**SANDOVAL COUNTY  
REGIONAL ANIMAL RESOURCE CENTER  
VISTA SANDIA COURT  
Bernalillo, New Mexico 87004**

**ADDENDUM NO. 02  
FY26 - SCPW - 07**

**December 5, 2025**

**C-301**

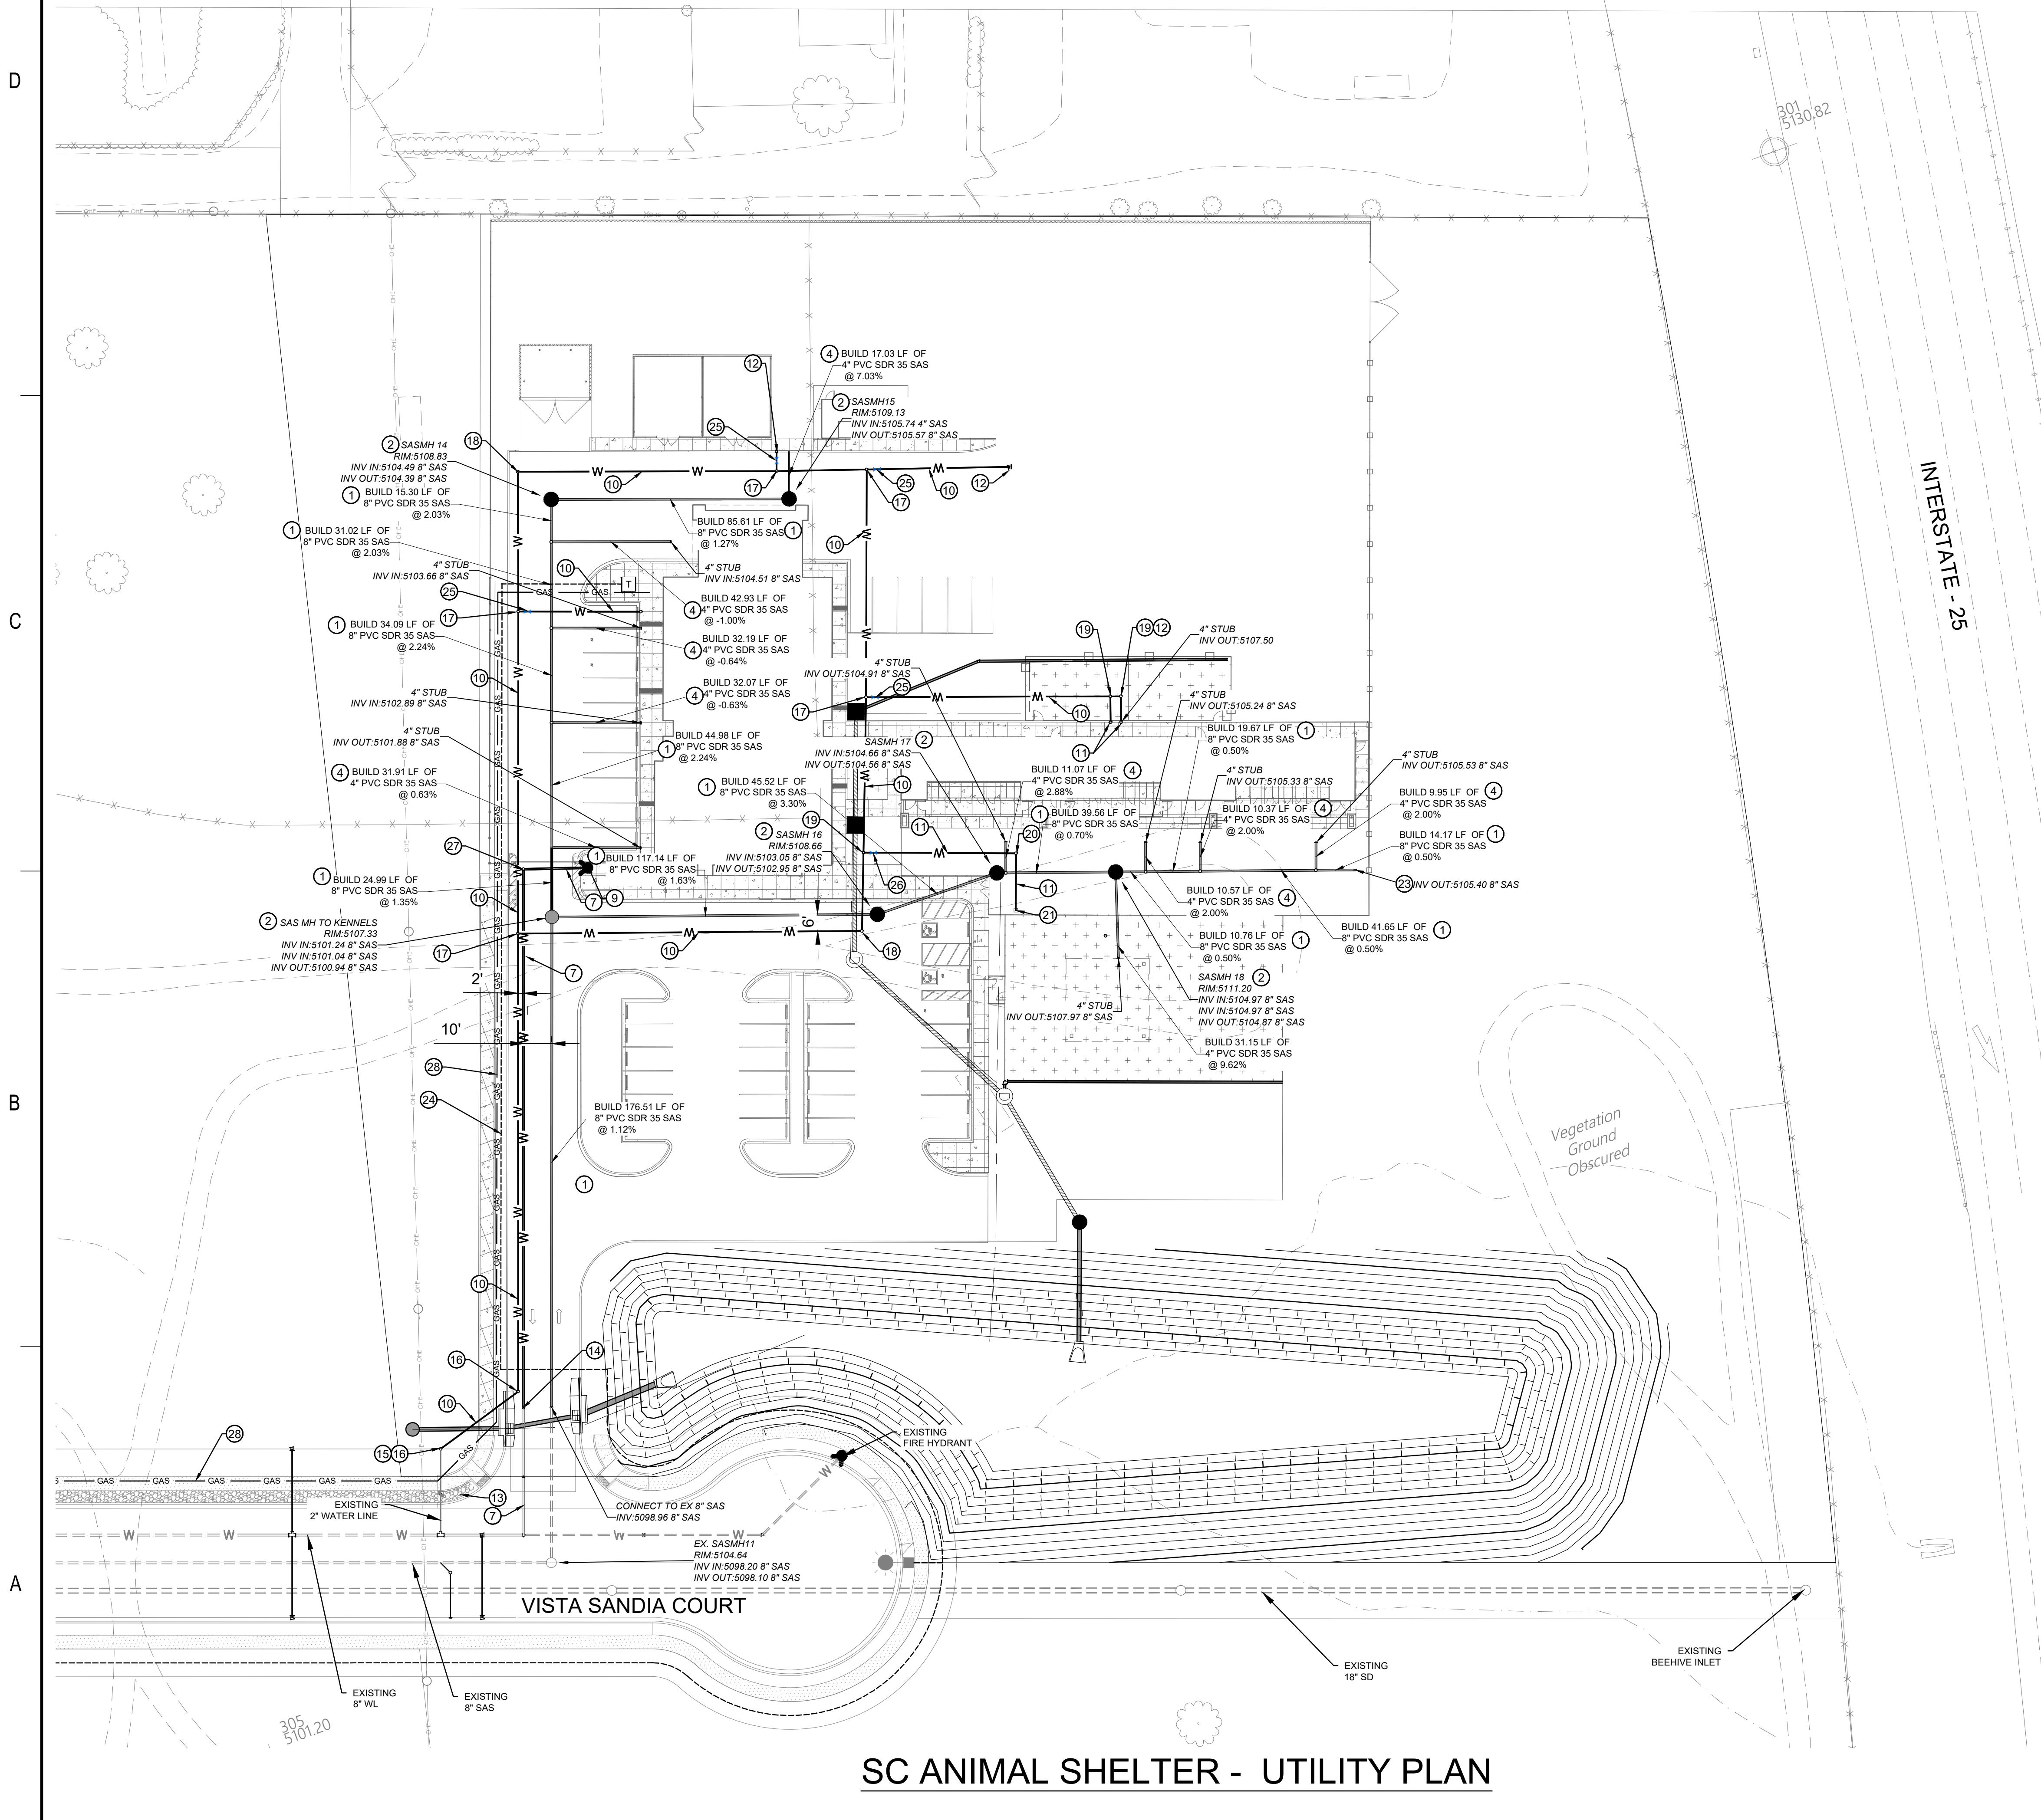
88. Gas line- P103 keynote 1 states to refer to civil site utility plan for coordination elevations and other additional information. There is no gas line on the utility drawings. Since the gas meter keynote 3 is at the building will the gas yard line be done by NM Gas Co.?

**Response: Closed-cell spray polyurethane foam (SPF) to fill gaps and voids.**
125. Gas Line - Sheet P-103 KN 1 states to reference Site Utility Drawings for Gas hookup, no gas line shown on Utility plan, please advise

**Response: Connection to sewer and 1" CW.**
136. Sheet P-101 KN 3 & 16 show items requiring coordination with grading however they are not reflected in the current grading drawings. Should these be included? Please advise.

**Response: Gas line added to Sheet C-301 Utility Plan, see attached. Gas service is to be constructed by NM Gas to the meter. Contractor shall coordinate with NM Gas for service to the building.**

**Response: Refer to revised Sheet C-301.**
126. The Grading Plan shows two Water Quality Inlets using squares, on the Utility page two additional squares are shown, do these also represent Water Quality Inlets?

**Response: Yes, Sand Oil Interceptor and Solids Interceptor should have been reflected in grading drawings. A SAS service has been added to Sheet C-301 for KN #3 on Sheet P-101. Finished Grade can be estimated for these features based on grading plan. Exact elevation can be provided during construction.**

**C-401**

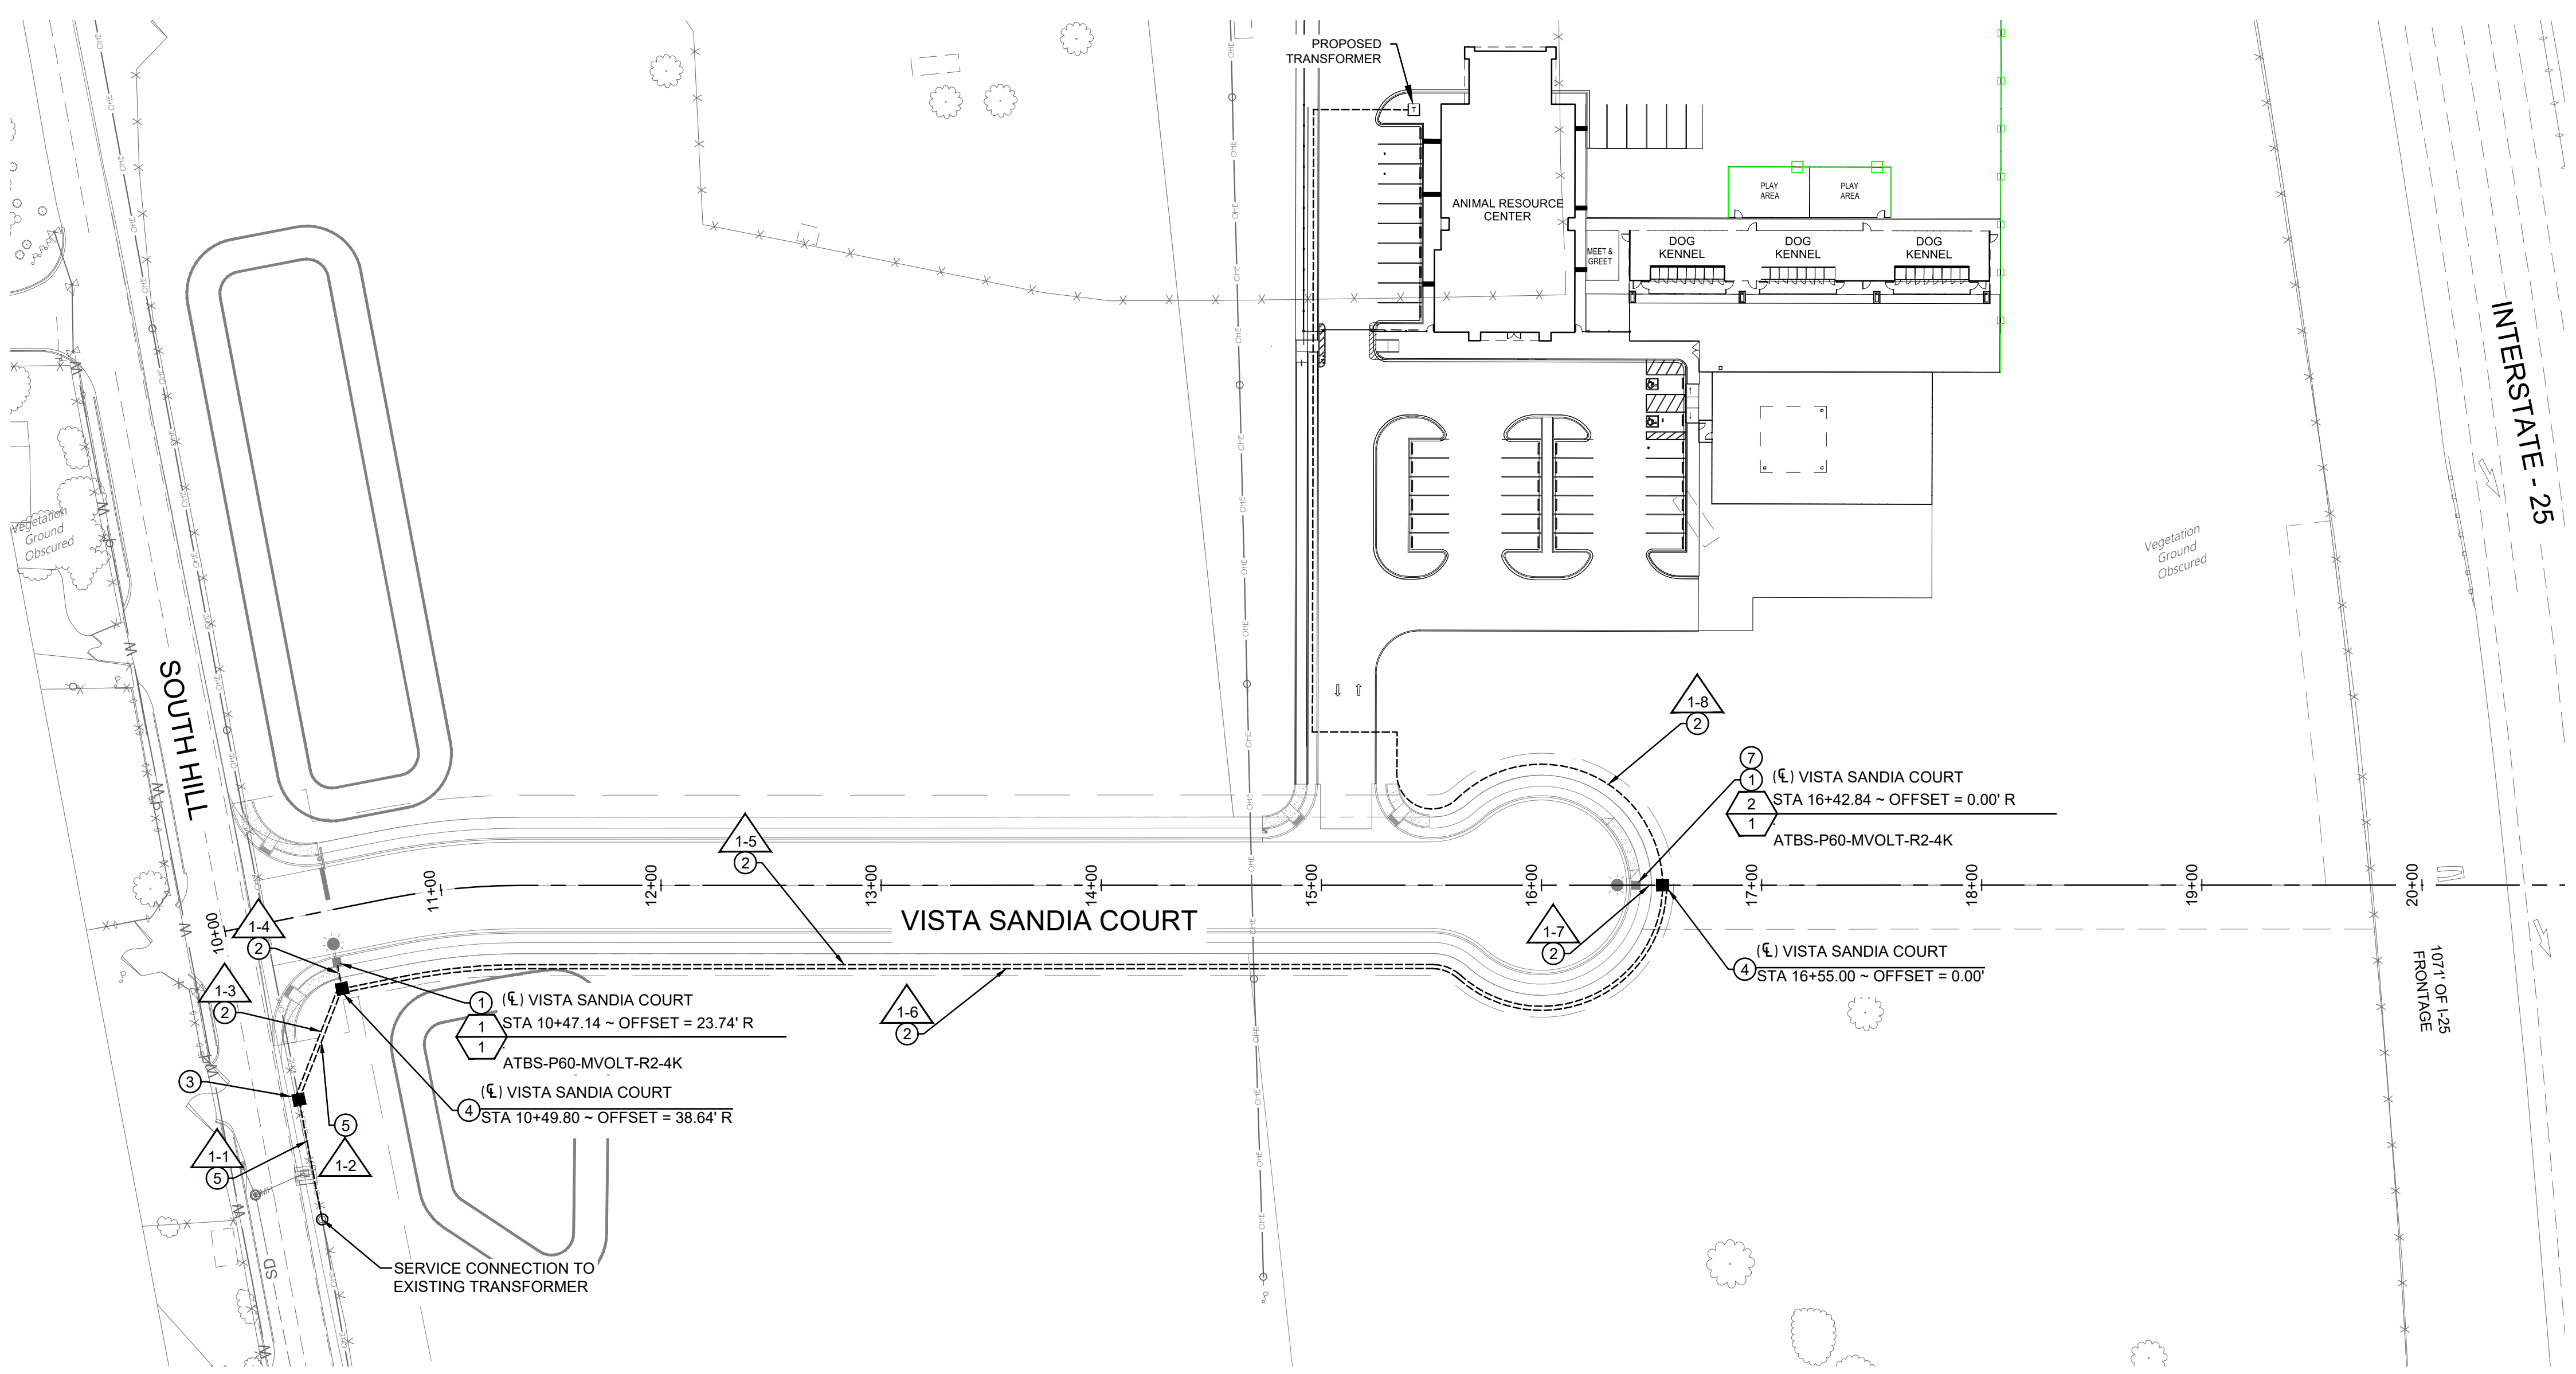
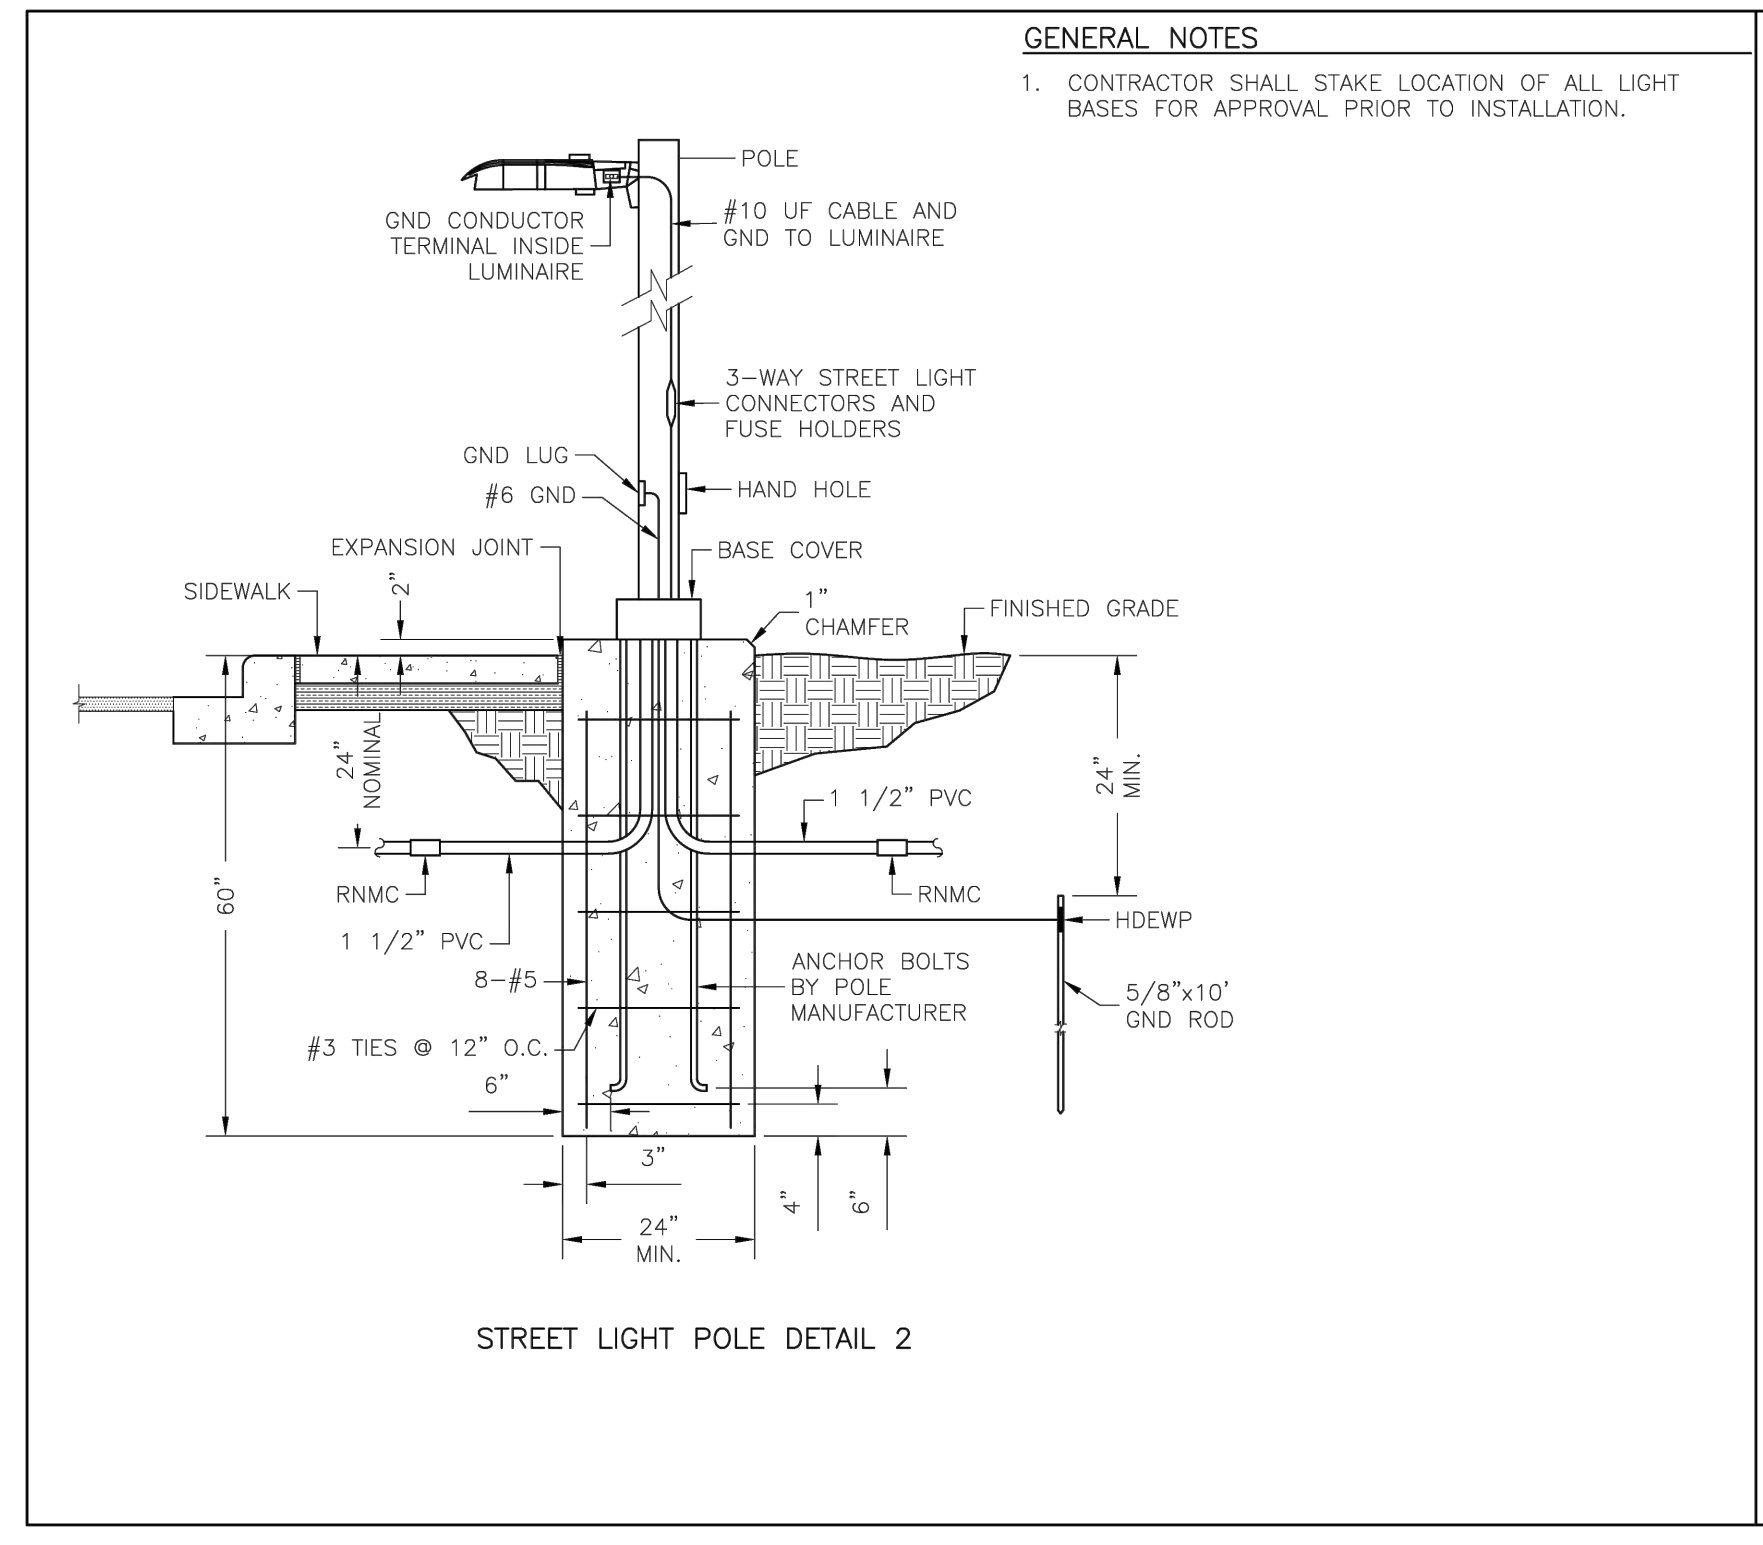
**Response: Provide per 09 7723.**
117. Metered Lighting Control Cabinet  
On Addendum Sheet C-401, Keynote #11 calls for a metered lighting control cabinet. We are not seeing KN #11 on the plan. Can you please confirm the correct location of this cabinet?

**Response: KN #11 is not used and has been deleted. See attached.**
118. HIP Shelter – Model Information  
Can you please provide details/specifications for the 24"x30" HIP Shelter (Steelworx Model #HP-2434-SW-4P), and confirm if this model—or an equal—is acceptable?
